RE: Mullan Road Elementary School Modernization and Addition

ADDENDUM NO. 1

ADDENDUM NO. 1

DWG. NO.
S-01

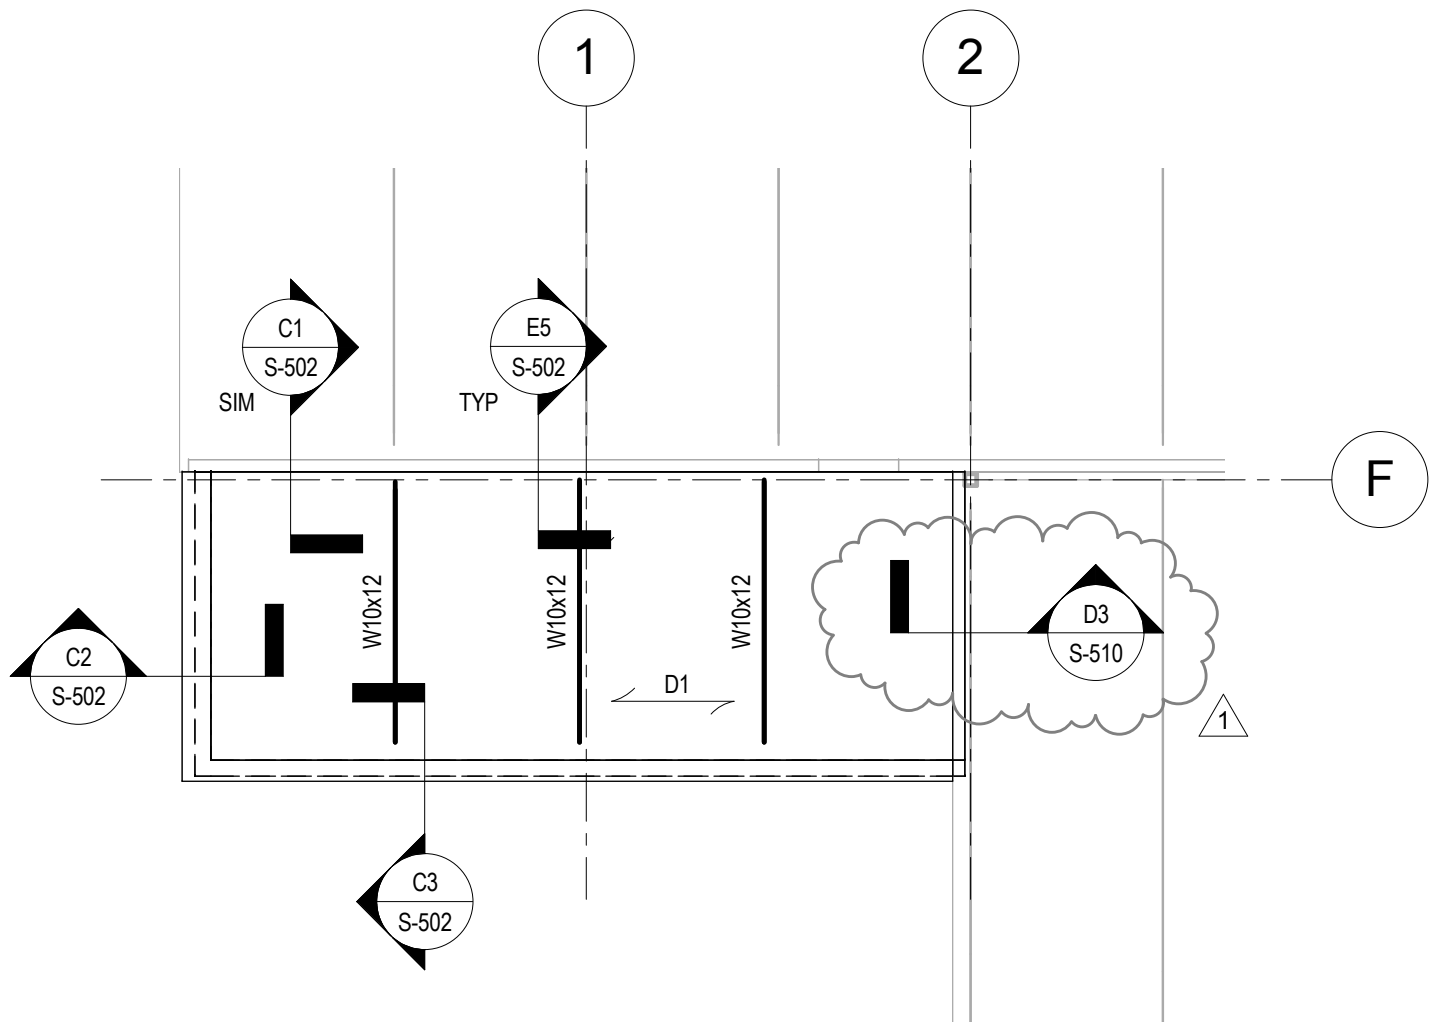
10.	Sheet S-112	See revision S-01.
11.	Sheet S-121	Change dimension from grid A1 to deck edge from 2'-6 5/8" to 2'-9", typical.
12.	Sheet S-502	Add detail B2/S-502 per S-07 attached.

DWG. NO.
S-02

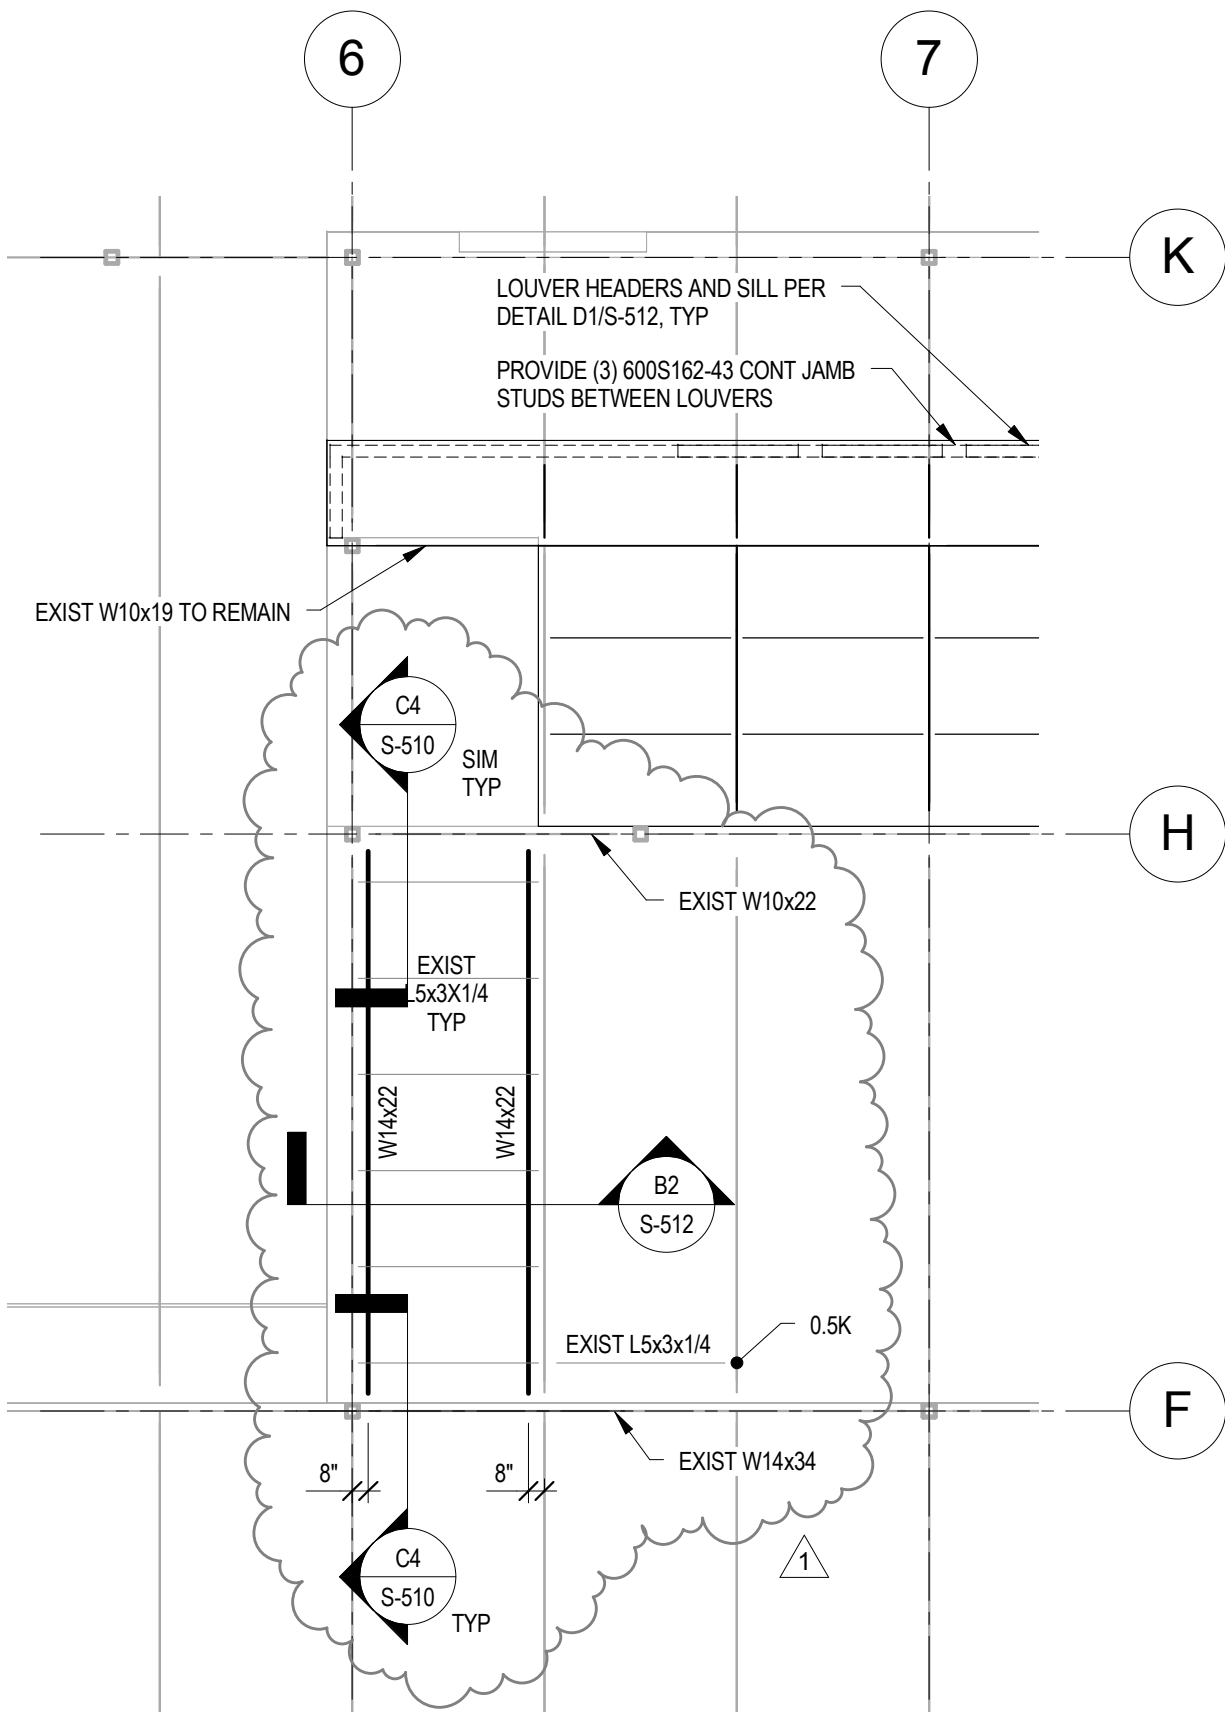
7.	Sheet S-111	See revision S-02.
8.	Sheet S-111	Change framing between grid F and H near grid 6 per S-03 for support of mechanical AHU-2 unit.
9.	Sheet S-111	Change detail call out at grid A.5 just west of grid 8 to read, C3/S-510, instead of C3/S-501.

DWG. NO.
S-04

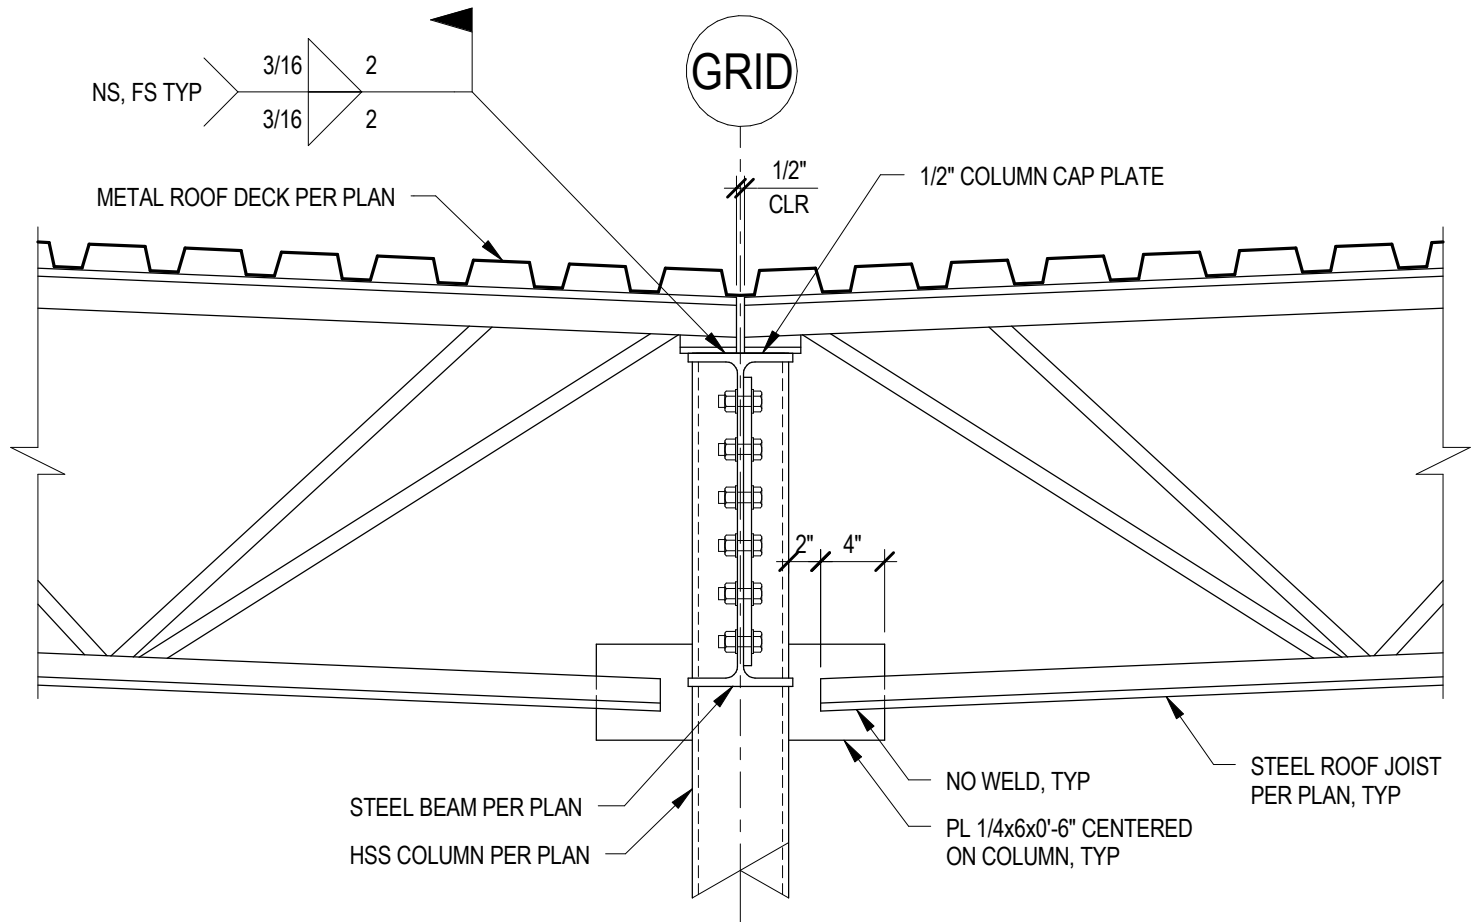
15.	Sheet S-510	Add detail C4/S-510 per S-04 attached.
16.	Sheet S-510	Add detail D4/S-510 per S-05 attached.
17.	Sheet S-510	Replace detail D3/S-510 (currently unused), with S-06 attached.

DWG. NO.
S-08

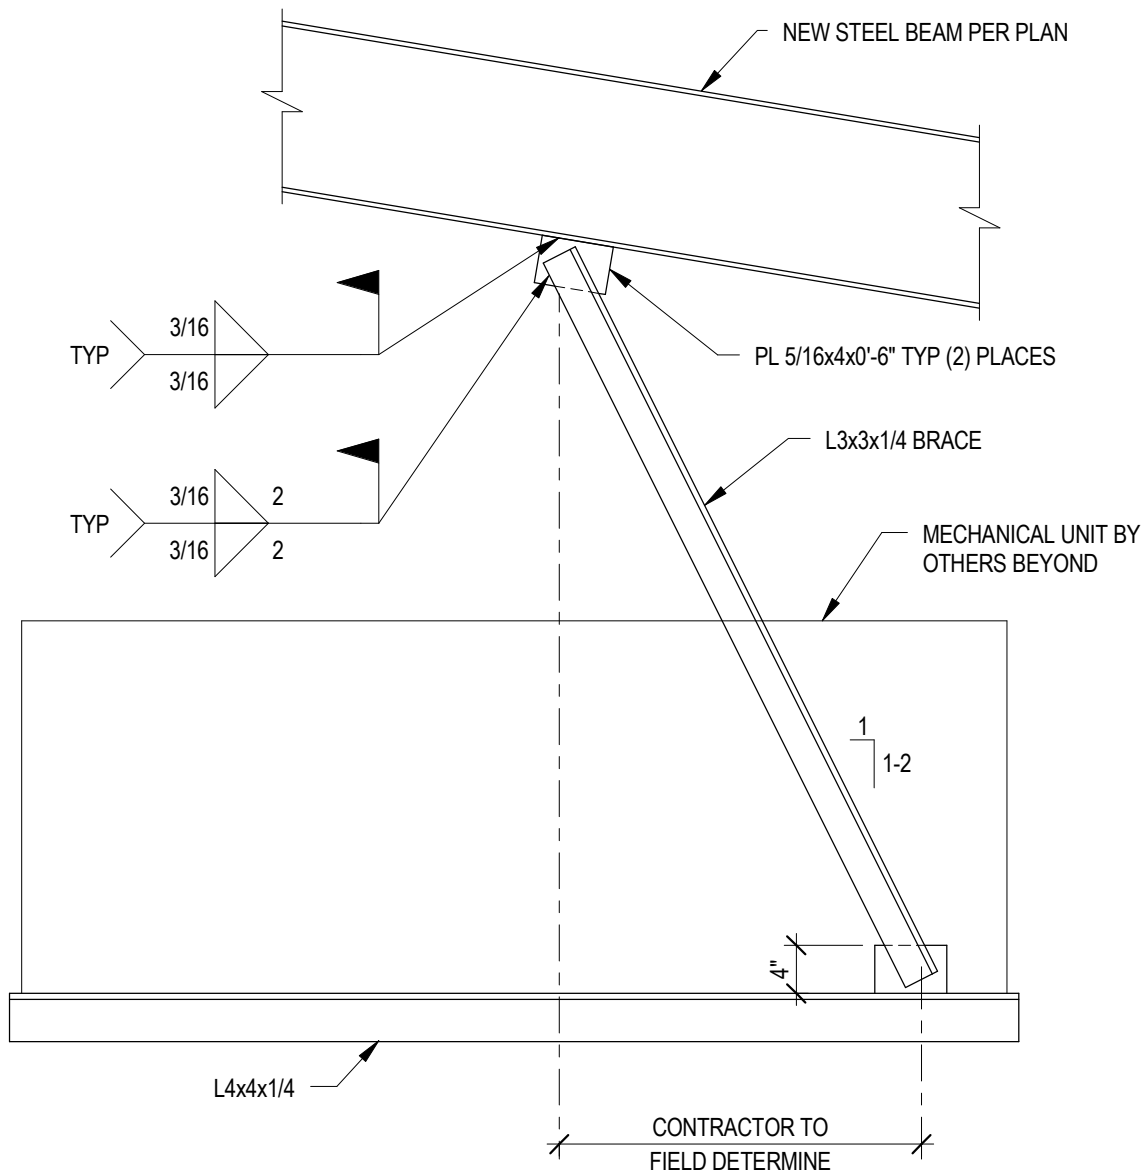
19.	Sheet S-512	Add detail B2/S-512. See S-08 attached.
20.	Sheet S-512	Add detail B4/S-512. See S-09 attached.

DWG. NO.
M-02

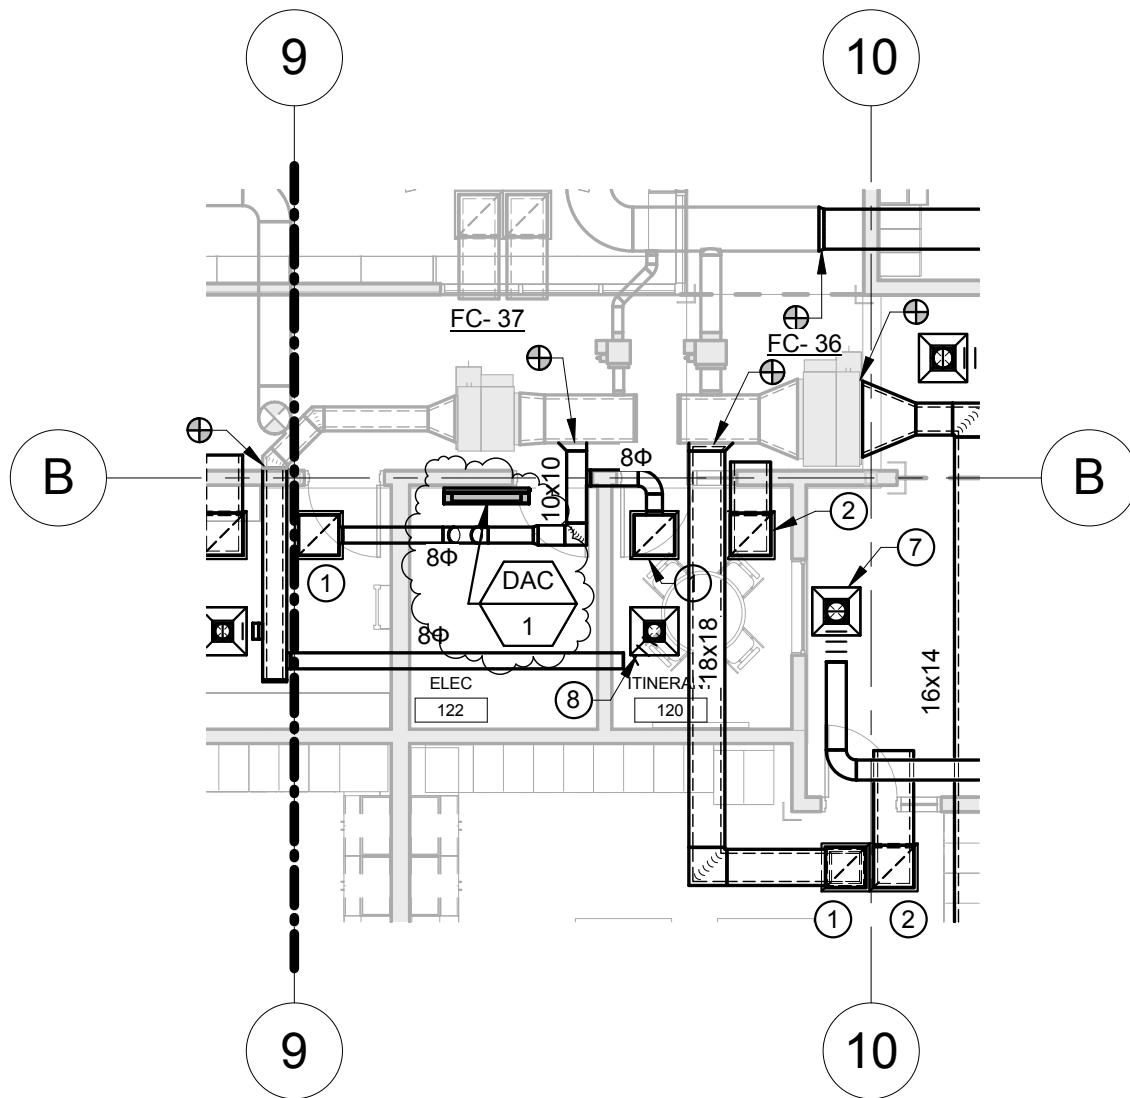
4.	Sheet M-123 – Electrical room 122	Add: ductless split system (DAC-1) and mount above door entrance. Route condensate piping down wall cavity to inlet side of p-trap on sink in 119-classroom. See attached addendum drawing M-02.

DWG. NO.
M-04

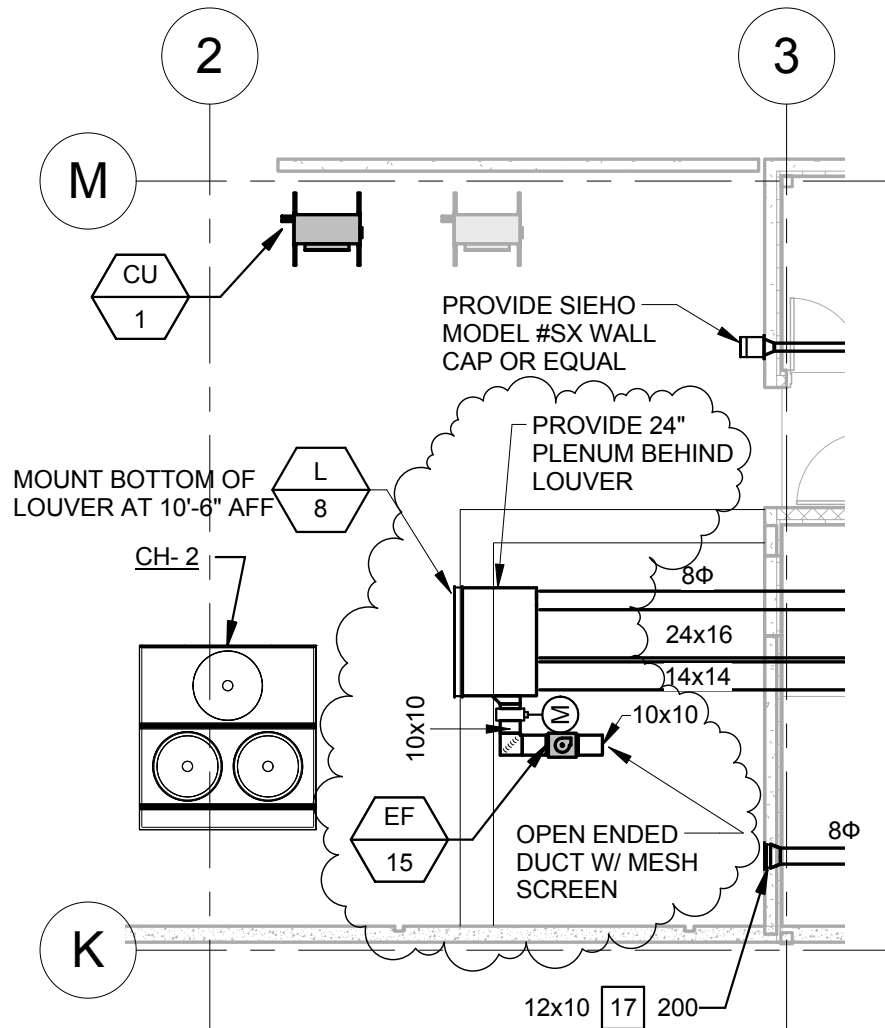
9.	Sheet M-601 – Exhaust Fan Schedule	Add: Exhaust fan EF-15. See attached addendum drawing M-04.

DWG. NO.
M-05

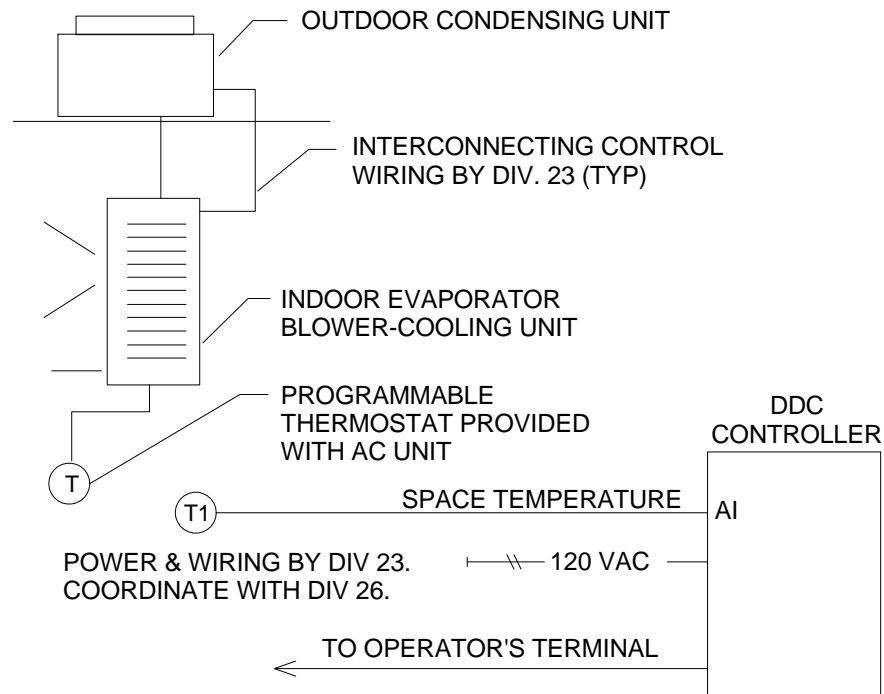
2.	Sheet P-601 – Roof Drain Schedule	Change DSN-1 to Model No. 1775 as manufactured by Jay R. Smith
3.	Sheet M-111 – Electrical room 140B	Add: exhaust fan (EF-15) and associated ductwork, motorized damper, and controls. See attached addendum drawing M-05.

DWG. NO.
E-01

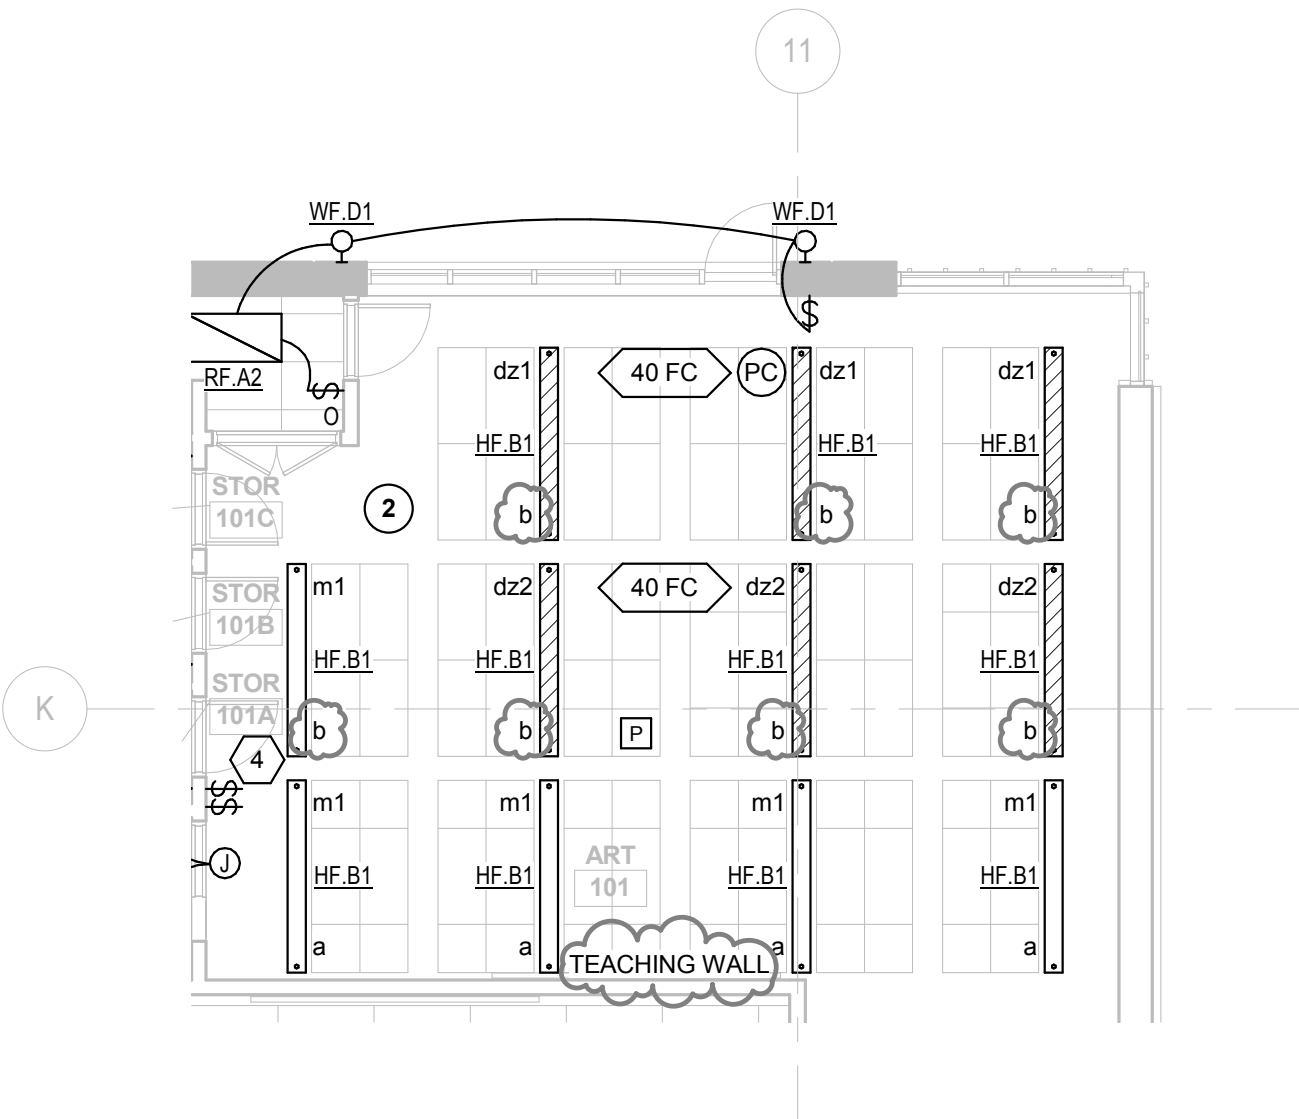
1. Sheet E-112
See attached clarification drawing E-01 for the re configuration of RM 140B and the addition of an ATS and panel EP-1WH5
2. Sheet E-105
See attached clarification drawing E-02 for revised switch groups in room 101.
3. Sheet E-705
See attached clarification drawing E-03 for revised panel schedules EP-1WH3 & EP-1WH4.
